NORTH ANNA POWER STATION, UNIT NO. 2

AMENDMENT TO FACILITY OPERATING LICENSE

Amendment No. 41
License No. NPF-7

SAFETY EVALUATION BY THE OFFICE OF NUCLEAR REACTOR REGULATION

FIGURE 2.1-1 REACTOR CORE SAFETY LIMITS FOR THREE LOOP OPERATION, 100% FLOW

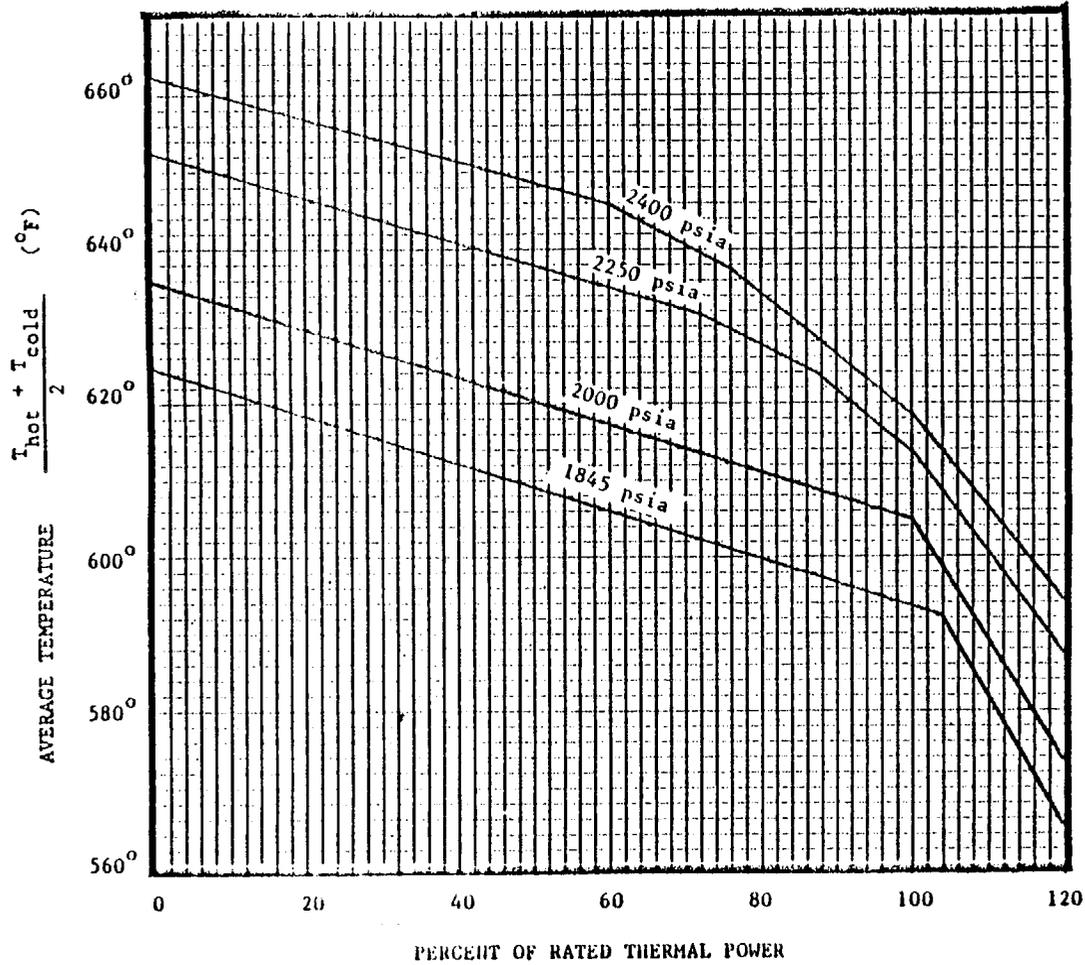
The amendment revises the NA-2 TS to allow operation with a Reactor Coolant System Average Temperature (RCS T_{av}) of 587.8°F. The amendment completes your Phase 1 and Phase 2 plant upgrade which increases secondary steam pressure in order to maximize the electrical output at the currently licensed reactor thermal power rating of 2775 Megawatts thermal. The amendment further revises the NA-2 TS to allow optimization of the core loading pattern by changing the fractional thermal power multiplier from 0.2 to 0.3 for a RCS T_{av} of 587.8°F.

2.1.1 The combination of THERMAL POWER, pressurizer pressure, and the highest operating loop coolant temperature (T_{avg}) shall not exceed the limits shown in Figures 2.1-1 for 3 loop operation and 2.1-2 and 2.1-3 for 2 loop operation.

Nominal Tavg: 587.8°F
 Nominal Design Flow: 285,000 gpm
